MFN 08-380

Docket No. 52-010

Subject: **Response to Portion of NRC Request for Additional Information Letters No. 121 and 132 Related to ESBWR Design Certification Application, RAI Number 19.2-41 S02 and 19.2-86 Respectively**

**Response to Portion of NRC Request for Additional
Information Letters No. 121 and 132
Related to ESBWR Design Certification Application
ESBWR Probabilistic Risk Assessment
RAI Numbers 19.2-41 S02 and 19.2-86 Respectively**

Figure 19.2-86(1) Liner Hoop Strains at Far Field, 260°C (500°F) Steady State, Median Values

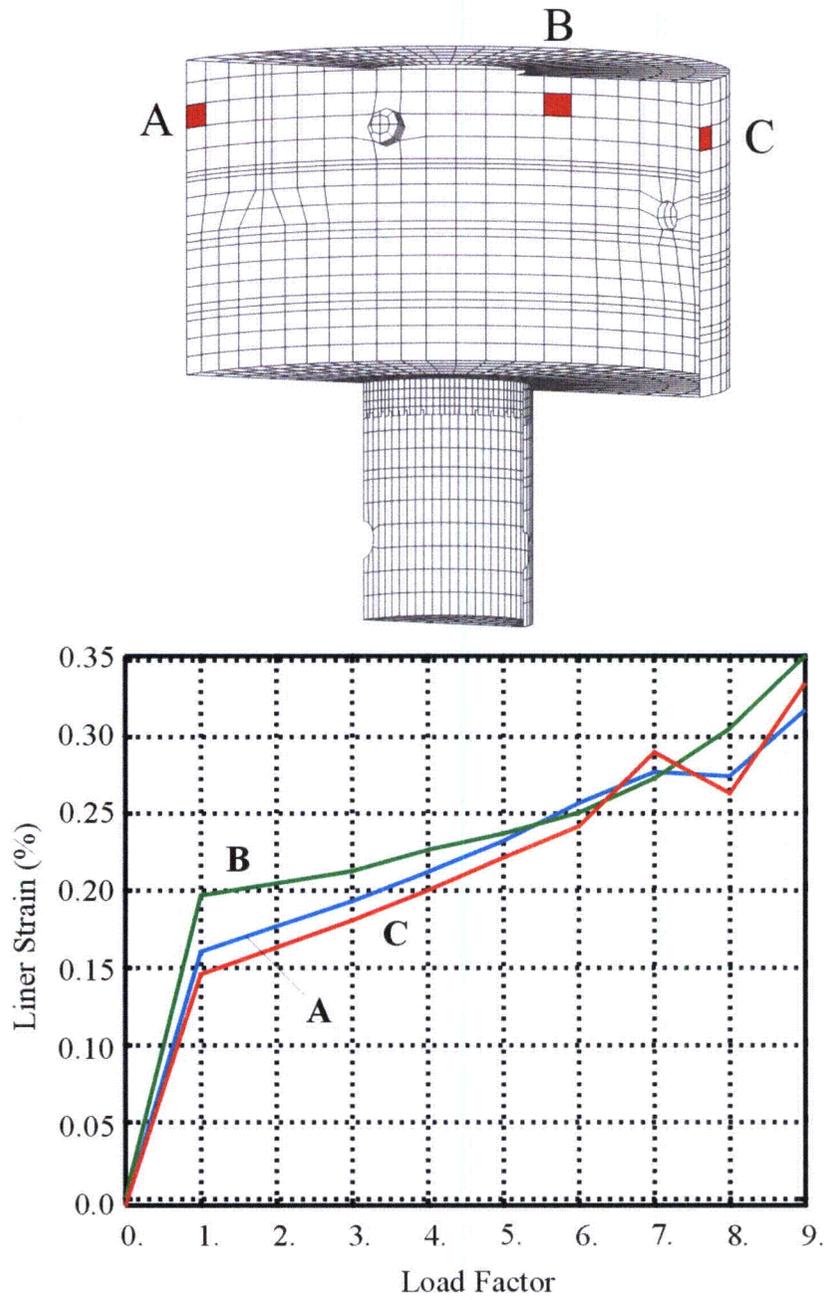
- a) whether the strain at location A of Figure 19B-5 was calculated based on membrane or membrane plus bending (if the strain is due to membrane plus bending, the code allowable factored load limit is 1%);*
- b) time histories of pressure and temperature on the liner due to WMR and a summary of thermal analysis which reduces the strain induced by the internal pressurization;*
- c) SRP 3.8.1, II, SRP Acceptance Criteria 4.K.i for computing ultimate pressure capacity of concrete containment states that "One acceptable methodology for cylindrical reinforced concrete containment is to estimate the capacity based on attaining a maximum global membrane strain away from discontinuities of 1 percent." Please assess if there could be a change in failure mode if 1% strain is used as the failure criteria for liners in place of Table 19C-5 of DCD, Tier 2, Revision 4, Appendix 19C.*

- b) The analysis to meet the Level C pressure capacity for 100% Water Metal Reaction (WMR) is not based on time histories of pressure and temperatures applied to the liner. The Level C capacity analysis applies dead load and then statically increments internal pressure up to the pressure corresponding to 100% WMR (0.987 MPaG). The side calculation to evaluate the effects of temperature on the liner strain used the temperature distributions from the 260°C

(500°F) steady state thermal conditions developed for the fragility analysis in DCD Tier 2 Appendix 19C. These temperatures were incrementally applied (starting from the ambient normal operating thermal conditions) along with the design pressure, and then the temperatures were frozen, and the internal pressure incrementally increased to that corresponding to 100% WMR. The Level C calculation with thermal was identical to the 260°C (500°F) steady state fragility analysis except the material properties were lower bound design values for the Level C analyses. The new Level C calculation reported in DCD Tier 2 Appendix 19B, Revision 5, will only be that for pressure and dead load. No side calculations to evaluate the effects of thermal strain will be included in the revised calculations.

Figure 19B-5. Maximum Principal Strains in Liner Near Discontinuities, Level C Analysis

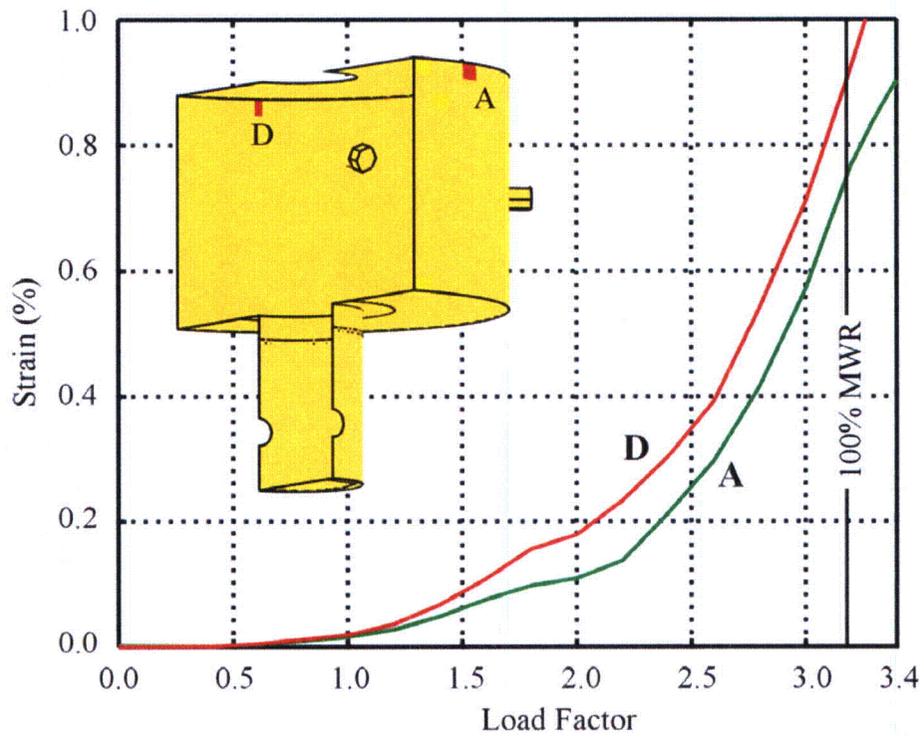
GEH further qualitatively justified that the liner strain could be reduced to within the factored load limit by accounting for the thermal induced strain, which is not consistent with the requirement of R.G. 1.7. Also, based on Figure 19B-5 of DCD, Tier 2, Revision 4, Appendix 19B, the excess liner strain appears to be a localized phenomenon (designated as location A in the figure). To facilitate the staff's evaluation, please provide:

- a) The liner strain calculated at the connection of the RCCV wall to the top slab contains both membrane and bending components. The excess liner strain is indeed a localized phenomenon occurring at 4 locations where large stiffness discontinuities exist at the RCCV to top slab connection due to the connections with the main pool girders. The code allowable factored load limit of 1% liner strain for membrane plus bending will be used for the calculated liner strain at these locations for the revised Level C calculations in DCD Tier 2 Appendix 19B, Revision 5.

Figure 19C-10. Bolt Stresses in Drywell Head for 260°C (500°F) Thermal Condition

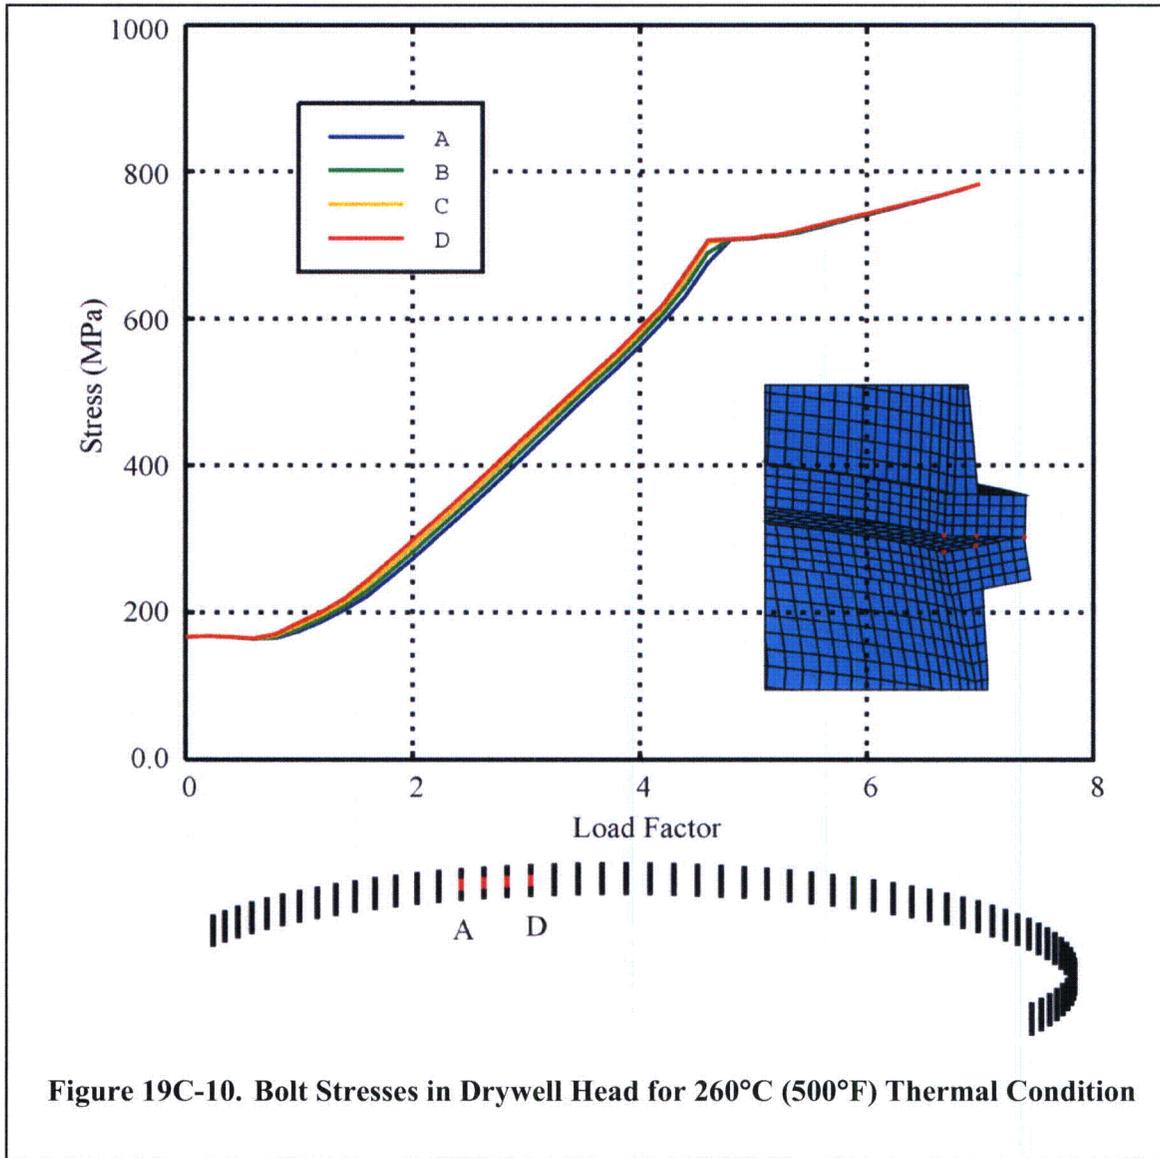
- (3) discuss o-ring degradation at the accident temperature;*
 - (4) provide a plot showing the average temperature of the flanges and the average temperature of the bolts, from initiation of the transient up to achievement of the steady state condition;*

- (5) describe the stress and deformation state of the bolted flange connection at the steady state condition; and,*
 - (6) provide the estimate of pressure capacity of the bolted flange connection at the steady state condition and technical basis for the estimate.*

- (5) The stress and deformation state of the bolted flange connection at steady state is described in DCD Tier 2 Appendix 19C. The internal pressure induces a prying action in the flanges as separation along the inner surface or heel develops. This produces a high compressive load outboard of the O-rings around the toe of the flanges, and eventually the bolts will yield in tension.

- (6) The estimate of the pressure capacity of the bolted flanges is 1.426MPaG (4.60 times the design pressure) for the 260°C (500°F) steady state accident condition. The 95% High Confidence value of the pressure capacity is 1.095MPaG (3.53 times the design pressure) for the 260°C (500°F) steady state accident condition. This includes the new temperature conditions and the new bolt material and bolt prestress loads. The technical basis for the estimate is the detailed, non-linear structural analysis as described in the attached DCD Tier 2 Appendix 19C, Revision 5 markup.

Figure 3G.1-51. Drywell Head

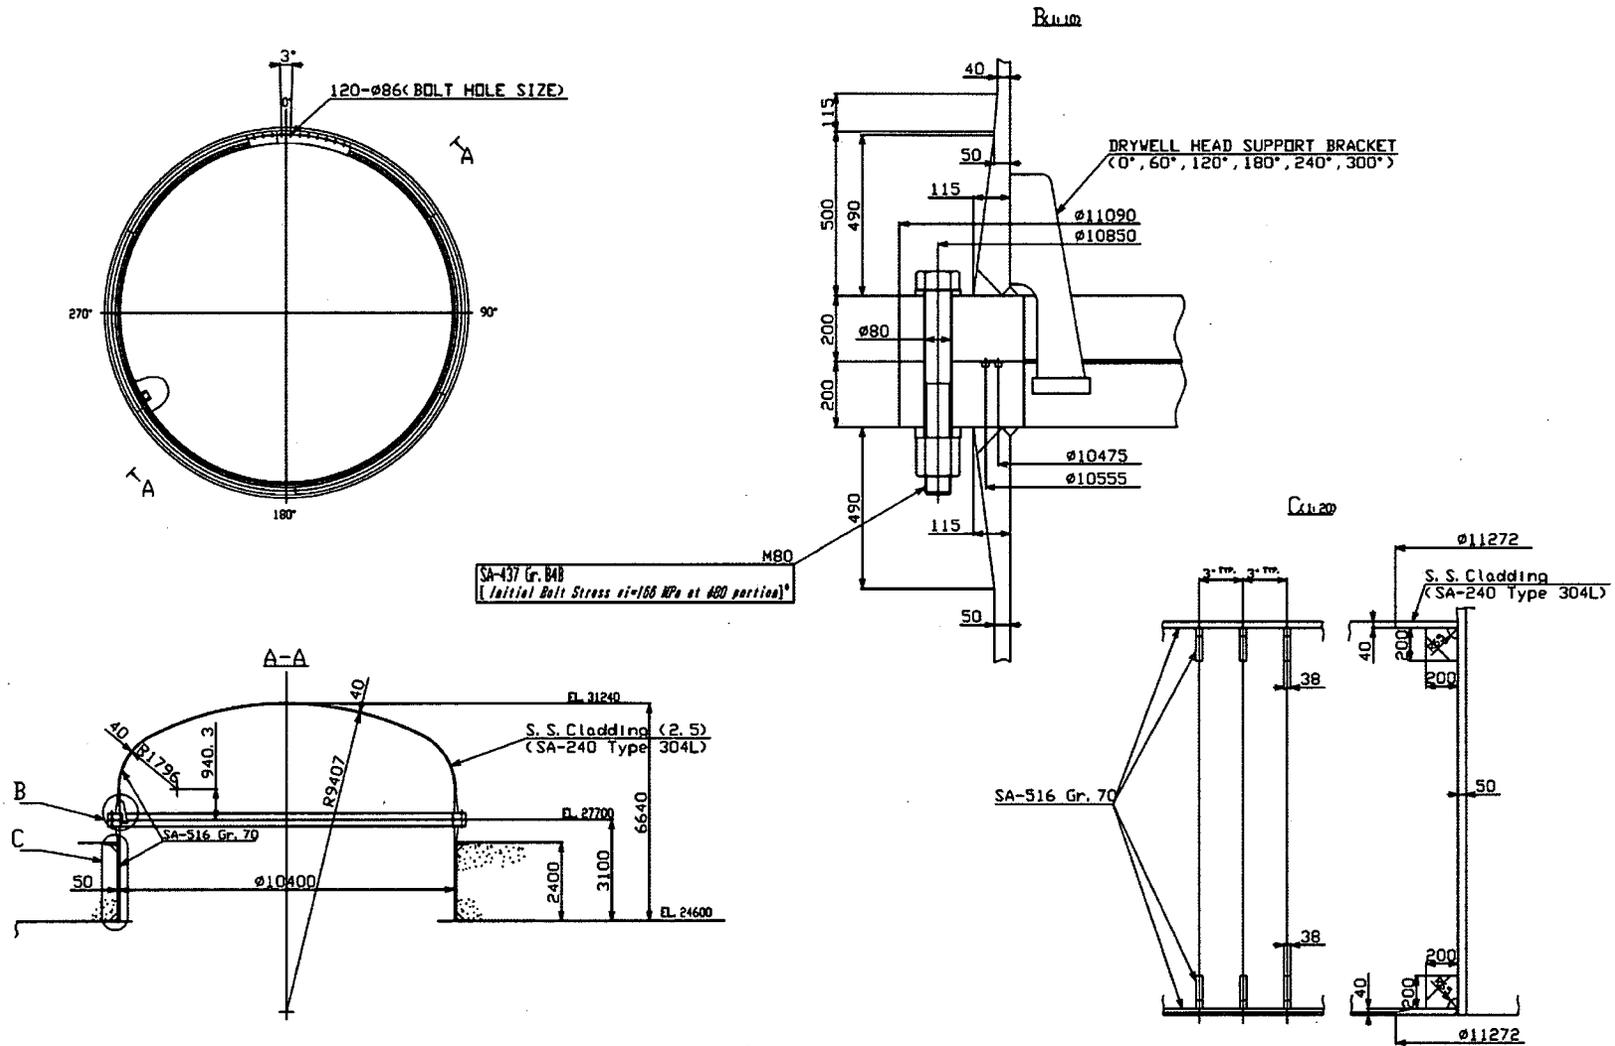
- (C) GEH indicated at the staff's February 5-7, 2007, on-site audit that the bolt preloads for the major penetrations will be set for the ultimate containment pressure capacity. However, the new containment performance analysis using ABAQUS/ANACAP-U as documented in the proposed DCD Tier 2, Appendix 19B, did not calculate the containment Level-C pressure capacity; rather it demonstrated that the containment Level-C pressure capacity will be higher than the pressure loads induced by the more likely containment accident scenarios and the 100% MWR. Therefore, GEH needs to stipulate quantitatively in Tier 2* the bolt preloads for the major penetrations including the drywell head, which were used in the ABAQUS/ANACAP-U analysis:*

(C) The bolt preloads for the drywell head, equipment hatch and wetwell hatch will be designated as Tier 2* information in DCD Tier 2 Figures 3G.1-51, 3G.1-52 and 3G.1-53.

DCD Tier 2 Appendices 19B and 19C and Figures 3G.1-51, 3G.1-52 and 3G.1-53 will be revised in DCD Revision 5 as noted in the attached markups.
